Under	the Fast-track Approvals Act 2024 ('FTAA')
In the matter of	a substantive application under the FTAA for an alteration to an existing designation, resource consents, a wildlife approval, archaeological authorities and a complex freshwater fisheries activity, to construct, maintain and operate the Belfast to Pegasus Project
By	New Zealand Transport Agency Waka Kotahi Applicant

Statement of Evidence of David Patrick Delegarza
(stormwater and flooding)

Dated 15 May 2026

**Belfast to Pegasus (B2P) Motorway and Woodend Bypass - Flood Assessment Report –
Commentary on work carried out by Aurecon**

Figure 2-20 Taranaki Stream 200-year Flood Duration Assessment

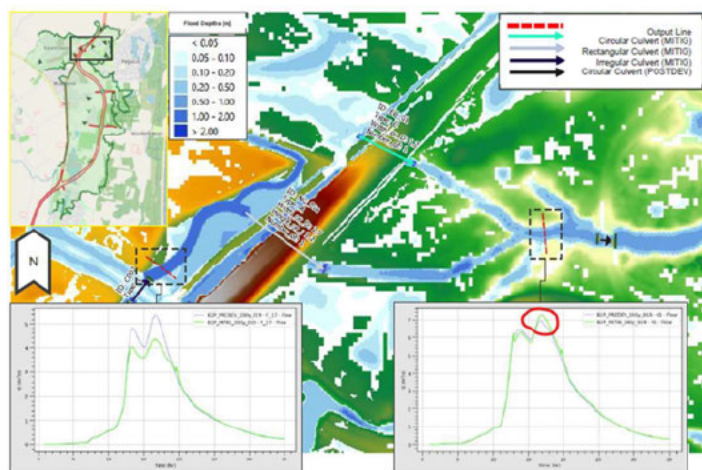
Flood levels and flows have increased along Taranaki Creek which is evident both in increased flood levels along Mapleham Drive and the flow hydrographs provided for the Taranaki Creek east of the new motorway.

I'm generally comfortable with the increased flood levels at Mapleham Drive and the nearest house (61 Mapleham Drive) appears to be clear of the increased flood depth. However, it would be good for Aurecon to confirm this as it is a little difficult to tell from the pdf maps.

The increase in flooding along the Taranaki may be more concerning. It is not clear whether the increase in flow here will result in issues further downstream on the Taranaki channel down to Waikuku Beach. It would be useful to see the flow hydrograph on the Taranaki near the boundary of the model to confirm whether this increase in flow is being felt further downstream or natural attenuation in the channel is offsetting the effects. If there is still a significant increase at this point then further work may be required to assess effects at Waikuku Beach.

Further work may be needed to confirm the additional flows will have no significant effects on the Taranaki Creek downstream to Waikuku Beach

Figure 2-24 Woodend Beach Road 200-year Flood Duration Assessment

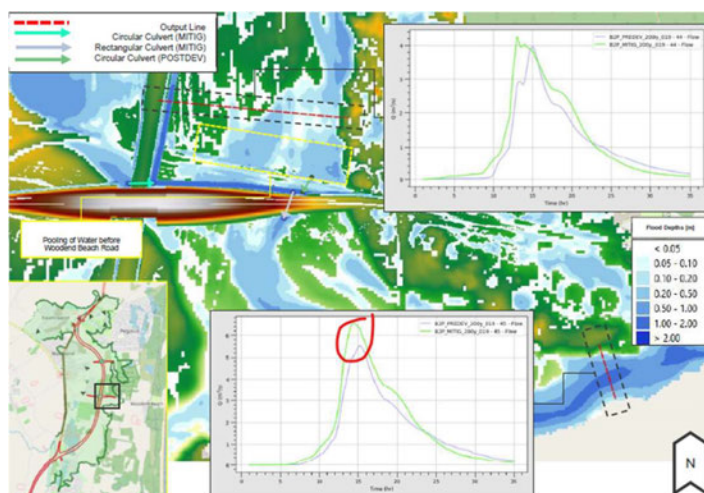
Flood levels and flows have increase on the Waihora Creek downstream of the

The report notes the additional flow but discounts the effects as there are no houses affected by the increased flooding within the model study area. However this takes no account of properties further downstream outside of the model study area.

Need to consider the effects of the increased flows in the Waihora Creek downstream of the study area to determine whether the effects are significant or not.

Figure 4: Hydrographs extraction at Line 34

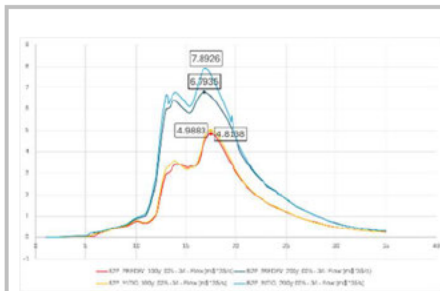
Issue	Aurecon Response	Council Response
Taranaki Creek Flooding		
1. Some small increases are shown on Taranaki Creek downstream of the project, however the impacts of the downstream impacts have not been assessed.	Some minor increases in flood levels are observed downstream of the project along Taranaki Creek. However, the overall downstream impacts are considered negligible. Figures 1 and 2 show the afflux mapping results for the 100-year and 200-year ARI events. Under the 100-year ARI event, the extent of afflux is limited to the immediate downstream of the Taranaki culvert, with a maximum rise of less than 60 mm. For the 200-year ARI event, the afflux remains contained within the defined overland flow path, with a maximum increase of less than 80 mm.	Accepted

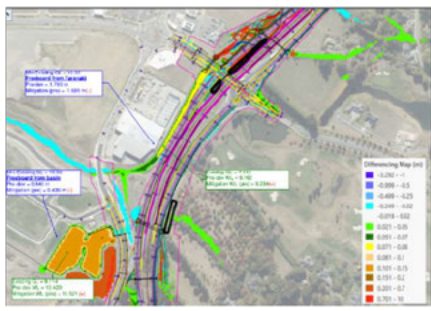
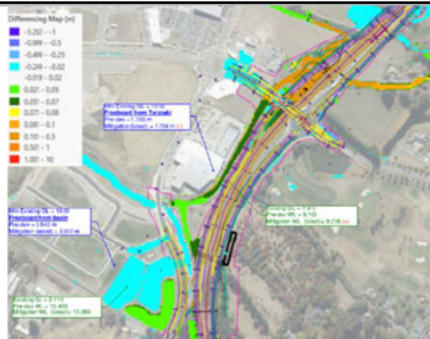
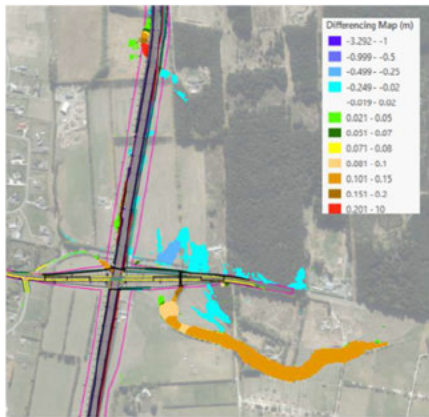
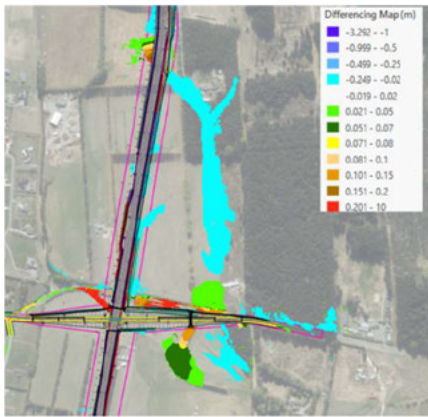
2. Aurecon has been working with

WDC to determine the appropriate of the pond overflow. WDC will be advising Aurecon on the decided outcome	Since then, the proposed road surface levels have been updated to match the existing weir level of 10.20 m. Figures 6 and 8 present the afflux maps (both 100 year and 200 year ARI) from the previously submitted model, while Figures 7 and 9 (both 100 year and 200 year ARI) show the results from the latest model incorporating the updated road surface levels. The previous submitted model generally shows higher water levels within the basin and wetland, which is mainly due to the higher weir level (10.40 m) previously proposed along Garlick Street. For the 100-year ARI event, both the previous submitted and latest models indicate a slight decrease in flood levels downstream. Under the 200-year ARI event, both models show a minor increase in downstream flood levels, with the previous submitted model showing slightly higher afflux overall. In the latest model, the downstream afflux is lower even though the basin stores less water. This occurs because the Taranaki culvert invert level has been lowered, allowing runoff to discharge downstream earlier. As a result, the latest model shows a slightly higher local afflux immediately downstream of the culvert compared with the earlier model. However, if the previous submitted model had used the same lower culvert invert, it would likely have shown a lower downstream afflux because more water would be retained in the basin. It may be worth considering whether the existing basin volume could be more effectively utilised by raising the proposed Garlick Street weir level to 10.40 m to provide additional upstream storage. Figure 6: 100 year afflux map at Ravenswood basin (previous submitted model result) Figure 7: 100 year afflux map at Ravenswood basin (latest model result)

Figure 8: 200 year afflux map at Ravenswood basin (previous submitted model result)	Figure 9: 200 year afflux map at Ravenswood basin (latest model result)																	
3. Updated report to include RL on the pond level vs surrounding roadways and houses to assess freeboard, etc	Figures 6 and 8 present the afflux maps (both 100 year and 200 year ARI) from the previously submitted model, while Figures 7 and 9 (both 100 year and 200 year ARI) show the results from the latest model incorporating the updated road surface levels. Results labelled (pre) refers to outputs from the previously submitted model, while (latest) are taken from the most recent model. In the latest model, the building near the Ravenswood basin shows an improvement, with freeboard increasing to 0.70 m under the 100-year ARI event and 0.610 m under the 200-year ARI event. The Harvey Norman building maintains a minimum freeboard of 2.106 m under the 100-year ARI event and 1.704 m under the 200-year ARI event, both well above the required minimum. In the previous model, the building adjacent to the existing Ravenswood basin showed a reduction in freeboard. However, it still maintained a minimum of 0.50 m under the 100-year ARI event and 0.439 m under the 200-year ARI event. To make better use of the available basin storage while maintaining the minimum freeboard to nearby buildings, the weir level could potentially be increased.		Accepted																
4. WDC has requested some information around the weir levels (consented, existing, modelled) - to be emailed to Don / WDC

<table><tr><td>Proposed weir level (latest model)</td><td>10.20 m</td><td>10.0 m</td><td>0.030</td><td>0.102</td></tr><tr><td>Proposed weir level (previous model)</td><td>10.40 m</td><td>10.0 m</td><td>0.054</td><td>0.104</td></tr></table>	Proposed weir level (latest model)	10.20 m	10.0 m	0.030	0.102	Proposed weir level (previous model)	10.40 m	10.0 m	0.054	0.104	
Proposed weir level (latest model)	10.20 m	10.0 m	0.030	0.102								
Proposed weir level (previous model)	10.40 m	10.0 m	0.054	0.104								
Note that for all modelled scenarios, the piped outlet structure from the SMA is assumed to be blocked.												
Waihora Creek												
1. The modelling indicates some increases are shown on Waihora Creek downstream of the project, however the impacts of the downstream increases have not been assessed.	Model results indicate minor increases in flood levels along Waihora Creek downstream of the project area. Figures 12 and 13 illustrate the afflux maps at the downstream of Woodend Beach Road. Under the 100-year ARI event, a maximum flood level increase of approximately 130 mm is observed downstream of Woodend Beach Road, primarily due to the upsizing of the Gladstone and Woodend Beach Road culverts. However, these increases remain well contained within the existing overland flowpath. For the 200-year ARI event, only a slight rise in flood level is observed (up to 61 mm) immediately downstream of Woodend Beach Road, with no noticeable afflux further downstream.   Figure 12: 100 year afflux map at downstream of Woodend Beach Road Figure 13: 200 year afflux map at downstream of Woodend Beach Road <td>Accepted</td>	Accepted										
2. Updated terrain modelling will include actual landform design, which will allow for more in channel flood storage and overflow to adjacent storage areas, reclaiming	Terrain has been updated in the latest model run to better represent the landform design.	Accepted

Figure 16: Bathtub extent at RL 1.165m closed to Stalker Road (Line 38)

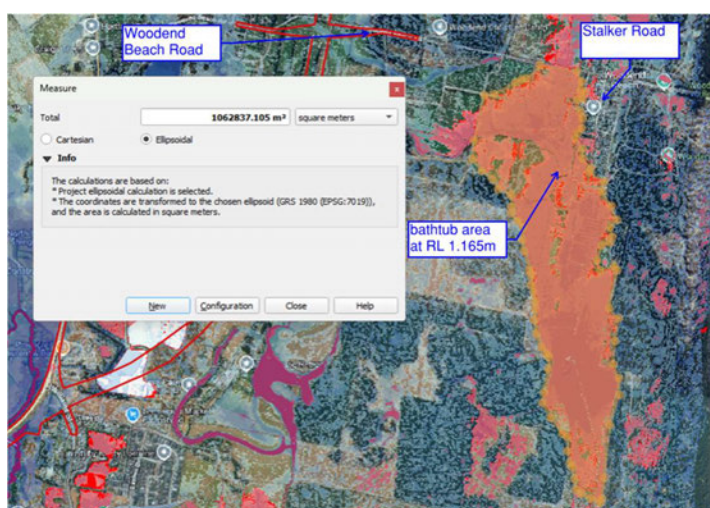
6. If there is still an increase in flood depths / volumes within Waihora Creek, Aurecon will generate a hydrograph at D/S boundary and conduct an assessment	To better understand the downstream impacts, a hydrograph was extracted at Line 38 (downstream of Woodend Beach Road). As shown in Figure 15, peak flow under the 100-year ARI event increased by approximately 1 m³/s, while the 200-year ARI event shows negligible change, which aligns with the afflux mapping results in Figure 12 and Figure 13.  Figure 14 Line 39 hydrograph extraction  Figure 15: Hydrograph at the downstream of Waihora Stream (Line 38)	Using a bathtub analysis Aurecon have estimated that the 200 year flood level will increase in the order of 29mm down at Woodend Beach based on increased flows along the Waihora. Whilst 29mm is not a

Further assessment was undertaken to estimate the potential change in flood level downstream of the model extent using a volumetric approach. Based on the hydrograph analysis, the increase in flow volume was estimated at

- 21,200 m³ for the 100-year ARI event
- 31,180 m³ for the 200-year ARI event.

Assuming a conservative “bathtub” storage extent as shown in Figure 16, with an existing ponding area of 1,062,837 m² at RL 1.165 m, the increment in water level was calculated to be approximately 0.029 m under 200 year event, resulting in a post-development water level of RL 1.194 m. Under 100 year event, the increment in water level was calculated to be approximately 0.020 m, resulting in post-development water level of 1.185 m

Figure 17: Flood Extents results from the Volumetric Assessment (Brown– Pre-development Scenario; Green – Mitigation Scenario)

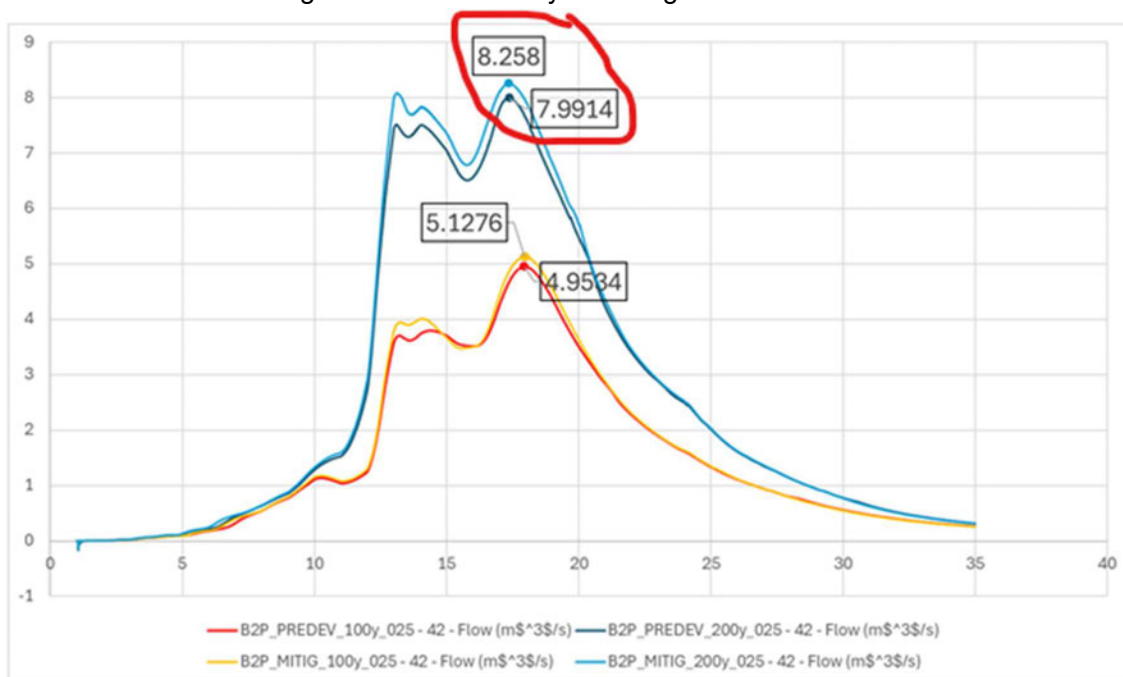
major increase in flood level and the bathtub analysis used is conservative it does however exceed our usual limit of 20mm where we would normally consider the effects to be less than minor. Of concern is the fact that under the 200 year event it appears some dwellings in Woodend Beach may be affected

2. Using a bathtub analysis Aurecon have estimated that the 200-year flood level will increase in the order of 29mm down at Woodend Beach based on increased flows along the Waihora. 29mm is not a major increase in flood level and the bathtub analysis used is conservative it does however exceed our usual limit of 20mm where we would normally consider the effects to be less than minor. Of concern is the fact that under the 200-year event it appears some dwellings in Woodend Beach may be affected (see diagram below).

As shown in Figure 17, the resulting flood extent from this volumetric assessment shows negligible differences compared to the pre-development condition. These changes are minor and do not affect any additional properties. The assessment is considered conservative, as it assumes no outflow from the ponding area while, in reality, with flow movement, the actual increase in flood level and extent would likely be lower.
